TECHNICAL MODIFICATIONS. 4802 – 4828 West San Vicente Boulevard; CFs 26-1289 and 26-1289-S1

Revised Architectural Plan

Exhibit A: Revised Architectural Plans, dated October 14, 2026

CONCEPTUAL FIRST FLOOR PLAN

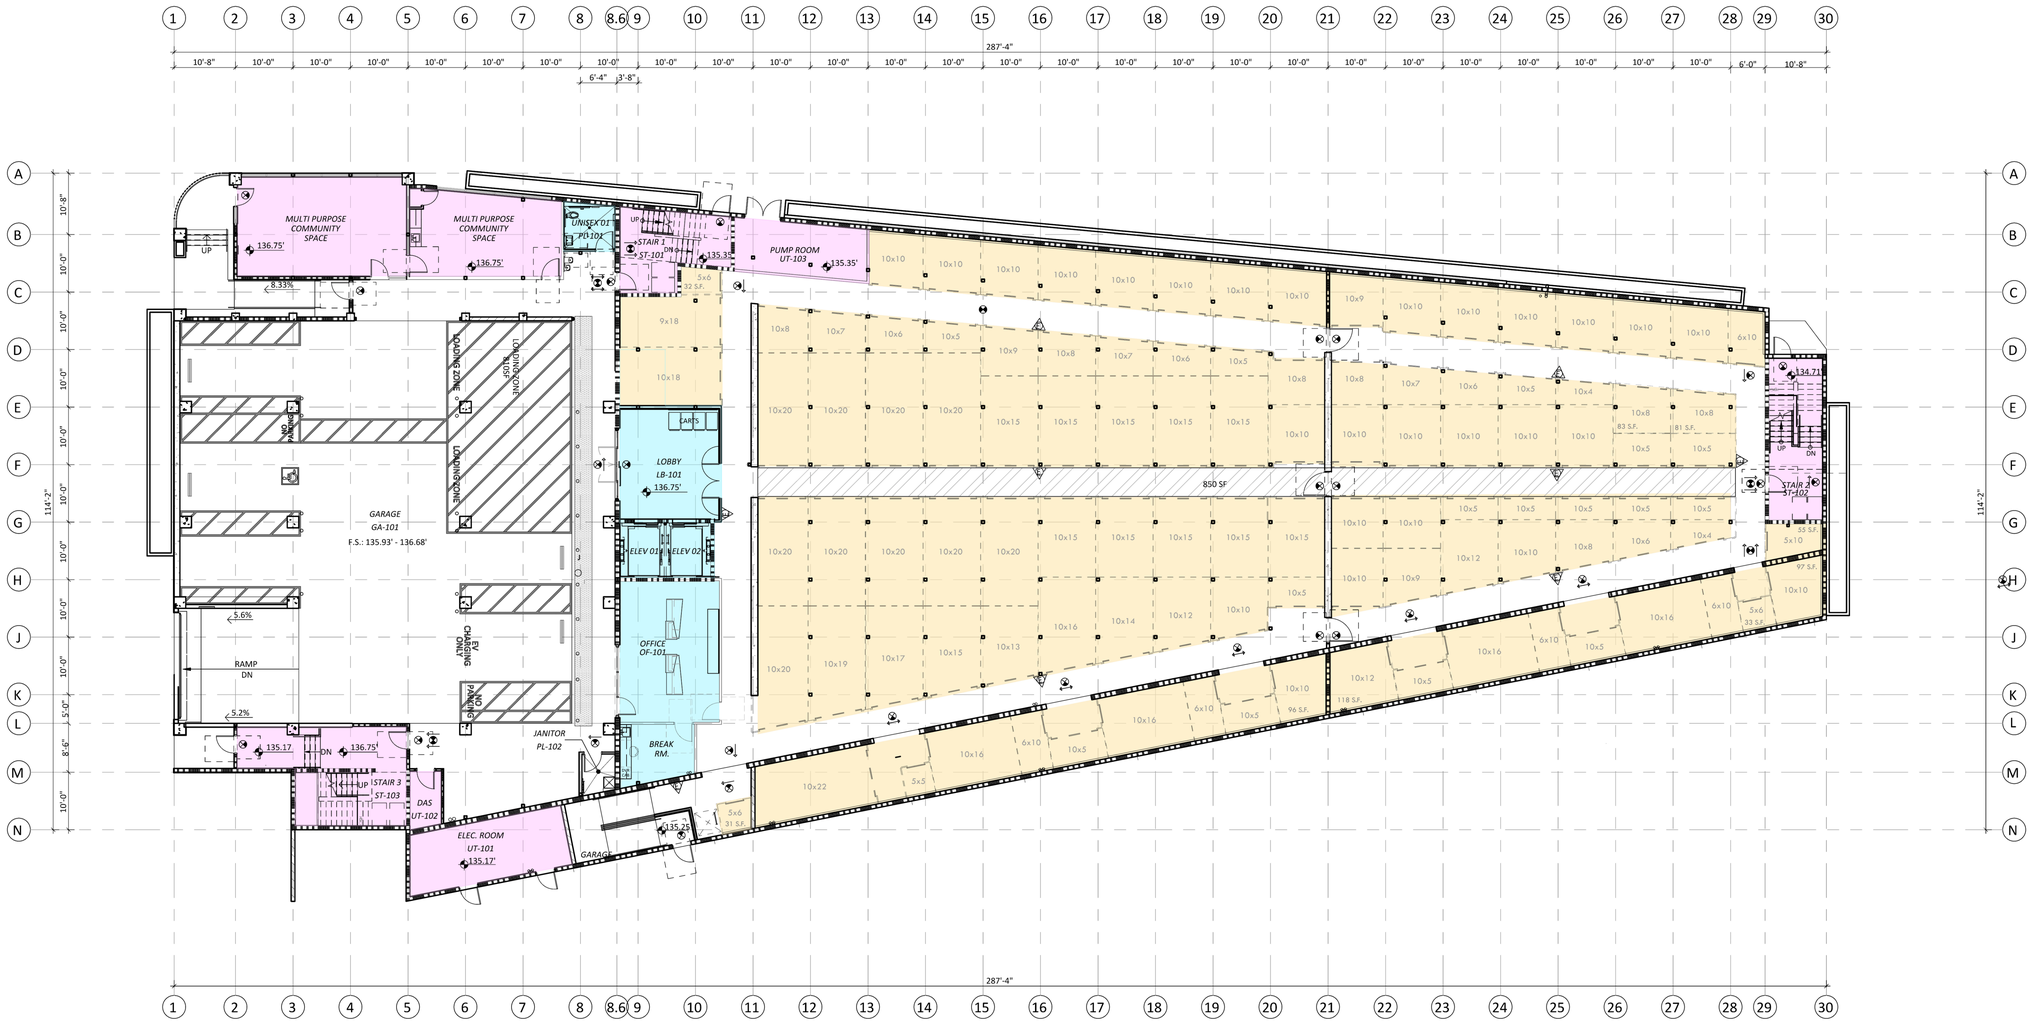
Following the issuance of the CPC Letter of Determination, the Applicant informed staff of minor revisions to the Exhibit A building plans to reflect an increase in the floor area of the multi-purpose community space area from 376 square feet to 954 square feet and relocation of the office area from the northwest corner of the building to the central area of the building, adjacent to the elevators and lobby. As shown in the attached revised architectural plans, dated October 14, 2026, the proposed revision will not result in substantive changes to the Project as the building envelope and total floor area will remain the same. The proposed revisions will result in the rearrangement of the areas used for office space, multi-purpose community space, and storage space, while the Project will maintain a floor area of 161,645 square feet and a floor area ratio (FAR) of less than 6:1 as previously approved by the CPC.

1. **Site Plan.** The use and development of the property shall be in substantial conformance with the plans submitted with the application and marked Exhibit "A", dated October 14 ~~June 23~~, 2026, and attached to the subject case file. No change to the plans (except as conditioned) will be made without prior review by the Department of City Planning and written approval by the Director of Planning. Each change shall be identified and justified in writing. Minor deviations may be allowed in order to comply with the provisions of the LAMC or the Project conditions.:
